**Subject: Notification of Class 1 Permit Modification Construction Updates for the Technical Area 63 Transuranic Waste Facility Container Storage Unit, Los Alamos National Laboratory Hazardous Waste Facility Permit, EPA ID # NM0890010515**

**Class 1 Permit Modification  
Construction Updates for the  
Technical Area 63 Transuranic Waste Facility  
Container Storage Unit,  
Los Alamos National Laboratory  
Hazardous Waste Facility Permit**

**EPC-DO-16-055**

Figure 1: TWF Utilities Figure (LANL, 2012)

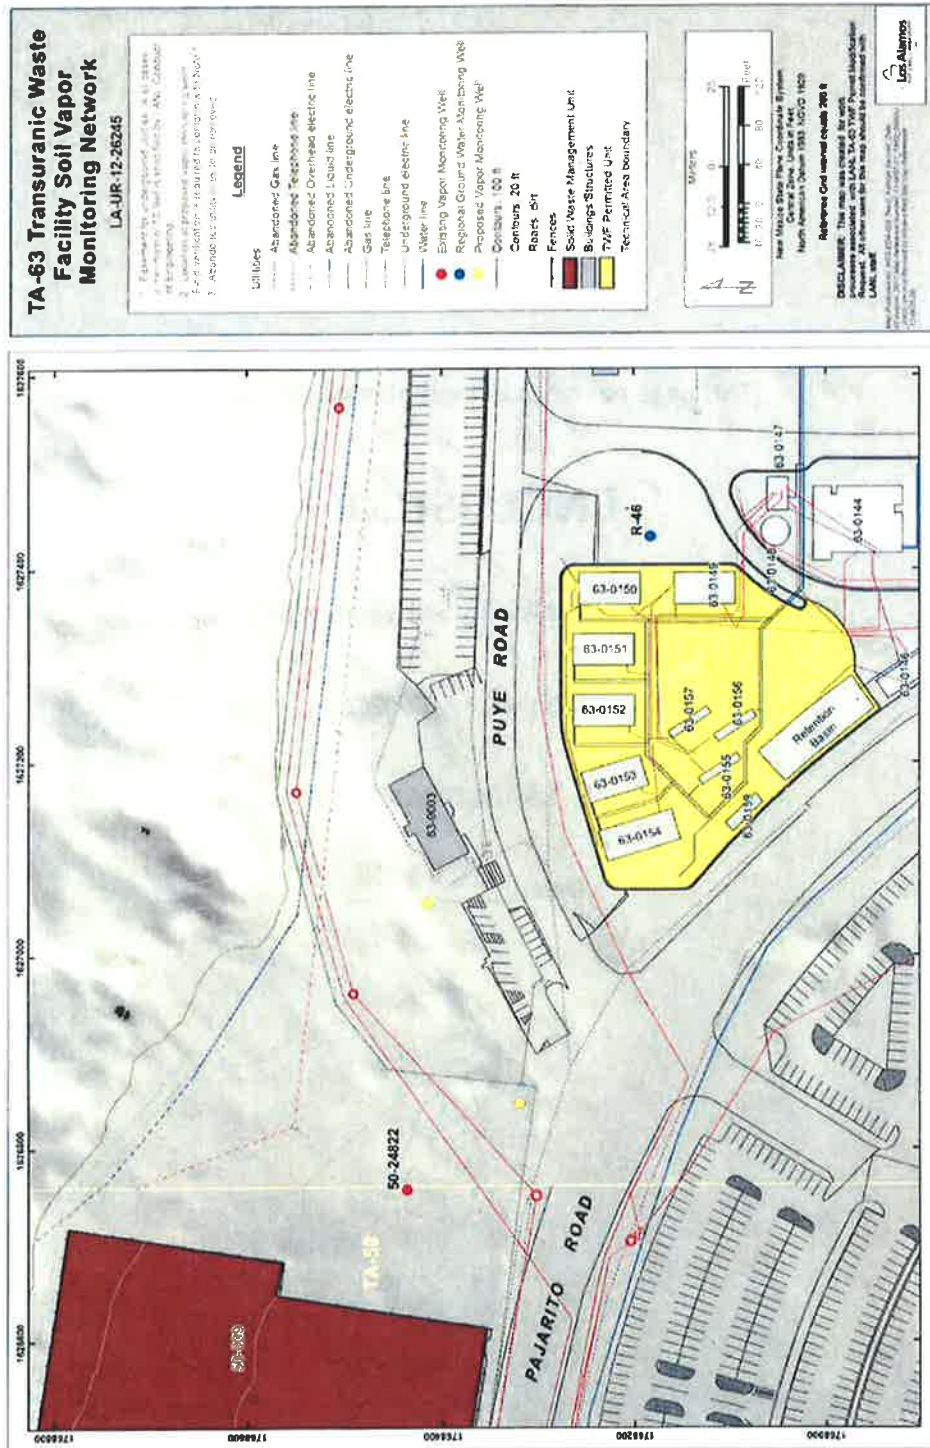
As originally designed and described in Permit Attachment A, *Unit Descriptions*, the TA-63 TWF had a fire suppression system including a 150,000 gallon tank and electric and diesel powered fire pumps to distribute water to automatic sprinkler systems in the storage buildings. The design capacity for the fire water storage tank was increased to 200,000 gallons and the tank has been constructed to that capacity. This represents a positive 25% increase in water available for a fire event but does not impact the design factors that were used to calculate the capacity for the retention basin (see Permit Section A.6.5).

Figure 2: Permit Attachment N, Figures, Figure 56, VMW-4 Location Edit

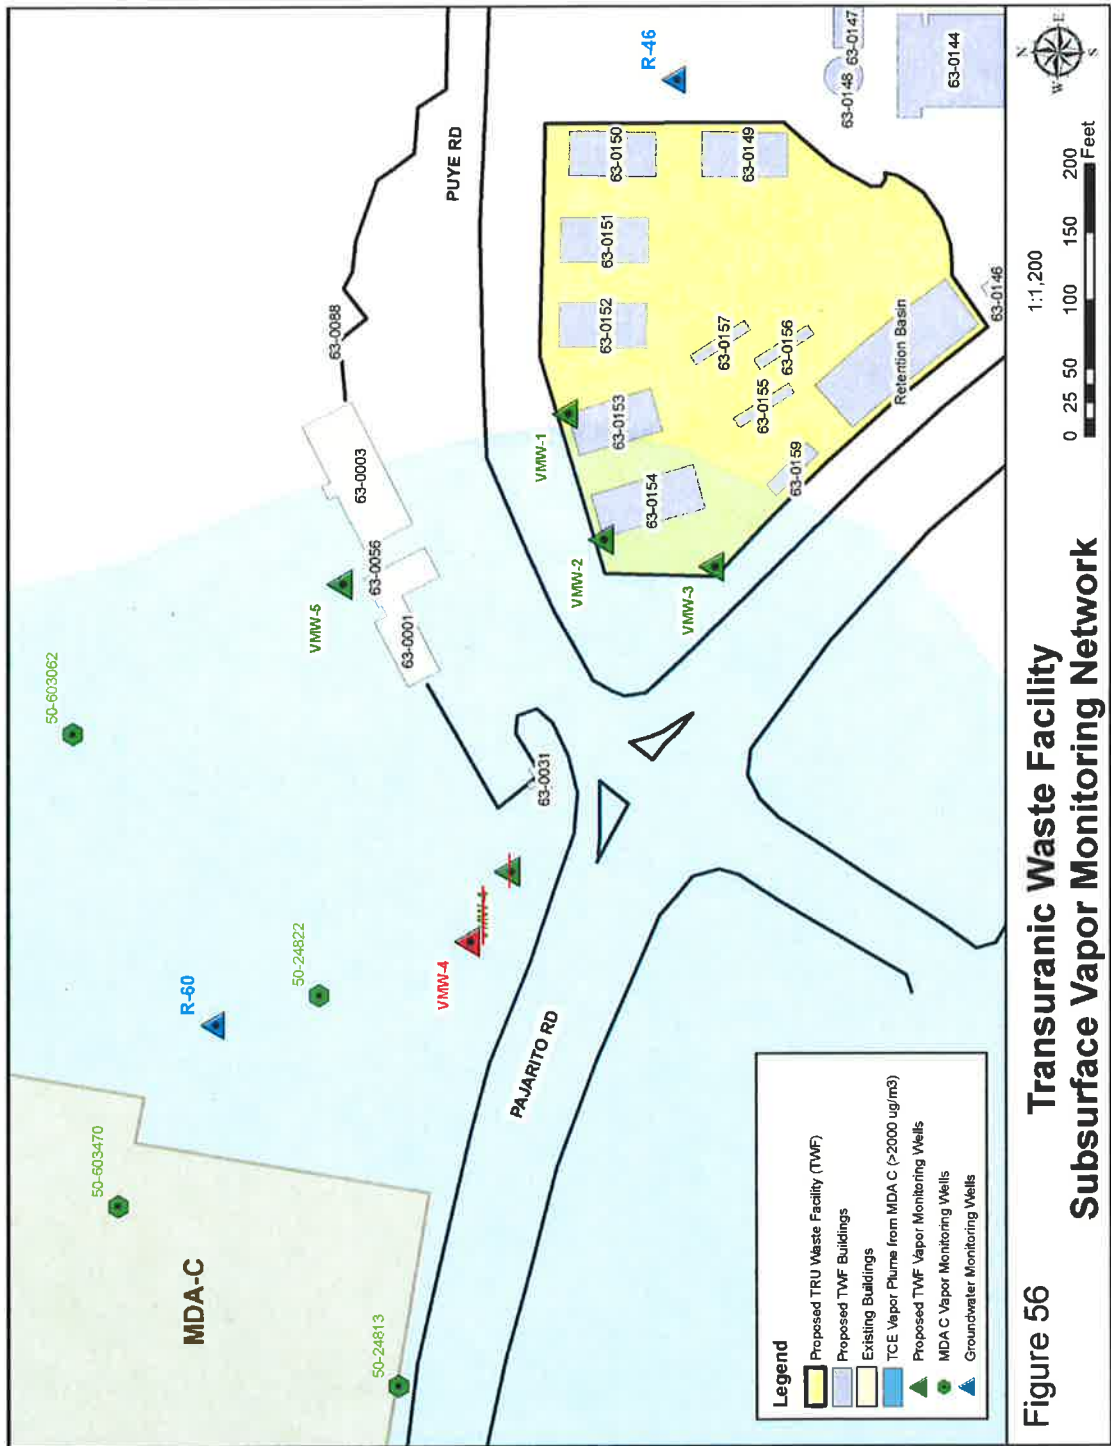
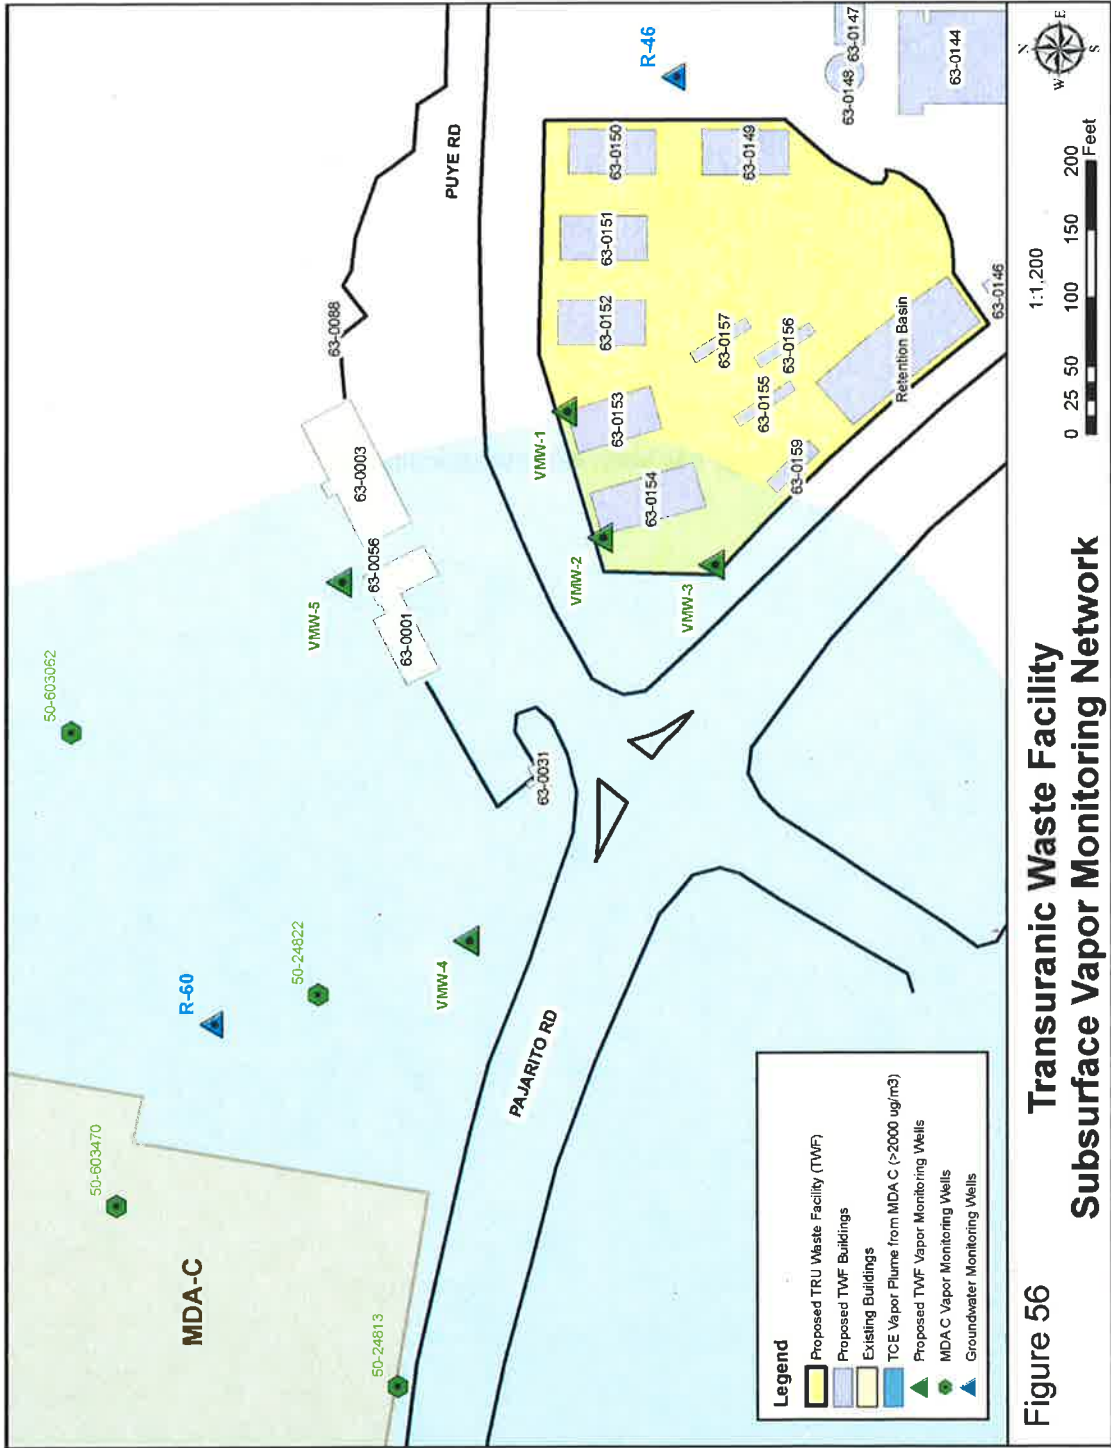
The *TA-63 Transuranic Waste Facility Soil Vapor Monitoring System Report*, submitted to NMED-HWB on October 29, 2015, includes a variance discussion at Section IV that describes a minor change in the location of the VMW-4 monitoring well. The location originally proposed for the monitoring well was situated in close proximity to an underground natural gas delivery line. This proximity is illustrated in a supplemental information letter submitted to NMED on December 6, 2012 (LANL, 2012). The figure included with the submittal shows that the proposed well location northwest of the TA-63 and the Pajarito and Puye Roads intersection is close to a gas line junction and an abandoned line (see Figure 1 of Attachment 9 of this submittal). LANL well siting procedures require a set-back to prevent accidentally drilling into utility services. The originally proposed location is also near a large drainage swale and the drilling site was relocated to the northwest to get better access to an existing dirt road for the drilling rig.

The direction of the move places the monitoring well a small distance closer to the source of the vapor plume being monitored. As included in the October 29, 2015 report, the soil vapor concentrations obtained in the first sampling event for the well were significantly below the soil gas screening levels included in Permit Section 3.14.3, *Subsurface Vapor Monitoring*. In addition, the nature of the VMW-4 sampling well with the position of the source for the vapor plume indicates the position is more closely identified with being a “sentry” location for early warning of soil vapor presence rather than an indicator of the effect of soil vapor emissions on the actual waste management activities at the TA-63 TWF storage buildings. That function is met by the soil vapor monitoring wells VMW-1 and 2 which were installed next to the storage area work buildings. VMW-4 is also not identified as a representative well for determining the effect of vapor emissions near a utility corridor as indicated for VMW-3 (NMED, 2013). The VMW-4 sampling depths of 25 and 60 feet are unlike the 5 foot sampling depth for VMW-3 and are deeper than utility corridor installation depths. For these reasons, there does not appear to be a significant effect associated with the location change.

This design change affects Figure 56 of the approved Permit. Figure 56 has been revised to account for the change in location of the VMW-4 soil vapor monitoring well. (See Attachment 9).

Figure 3: Permit Attachment N, Figures, Figure 56, VMW-4 Location Revision
